## **BETTY J. WILLIAMSON SUBDIVISION**

APPLICATION NUMBER 7 DATE December 7, 2006

REQUEST Subdivision

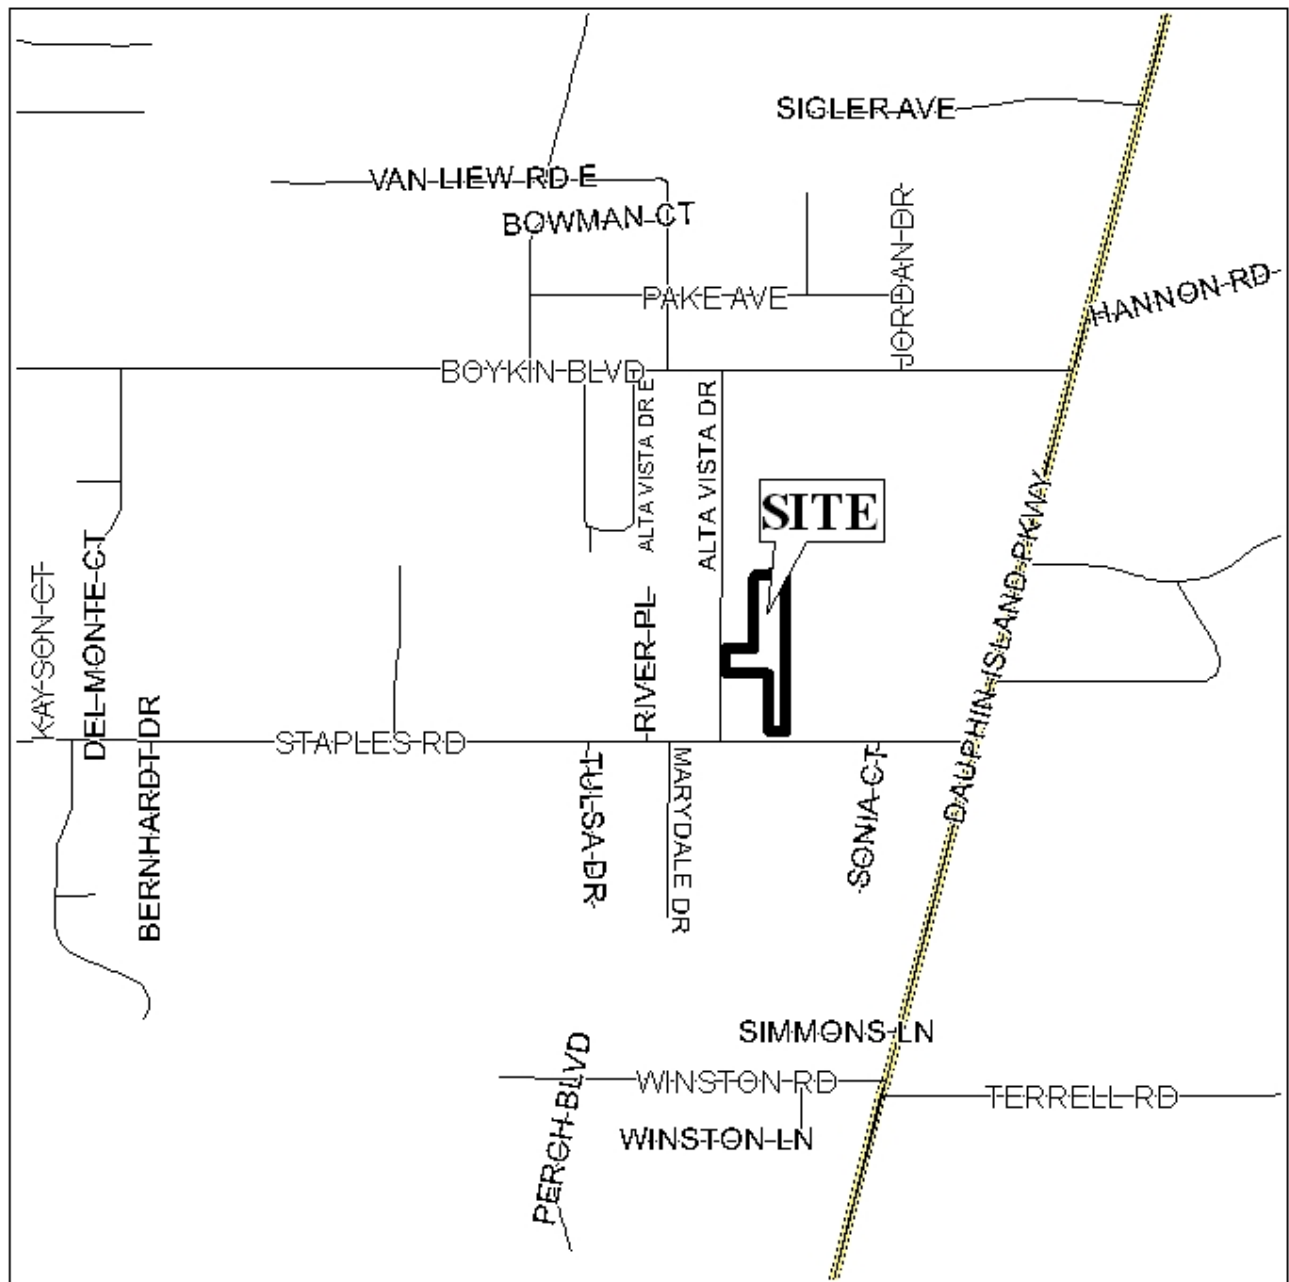
The plat illustrates the proposed 1.4 $\pm$  acre, two lot subdivision which is located at 1754 Staples Road and 3901 Alta Vista Road (North side of Staples Road, 205' $\pm$  East of Alta Vista Drive, extending to the East side of Alta Vista Drive, 280' $\pm$  North of Staples Road). The subdivision is served by city water and sanitary facilities.

The 25' building setback is not shown but will be required on the final plat.

Based on the preceding, it is recommended that the plat be granted Tentative Approval, subject to the following condition: 1) placement of the required 25' building setback line on the final plat.
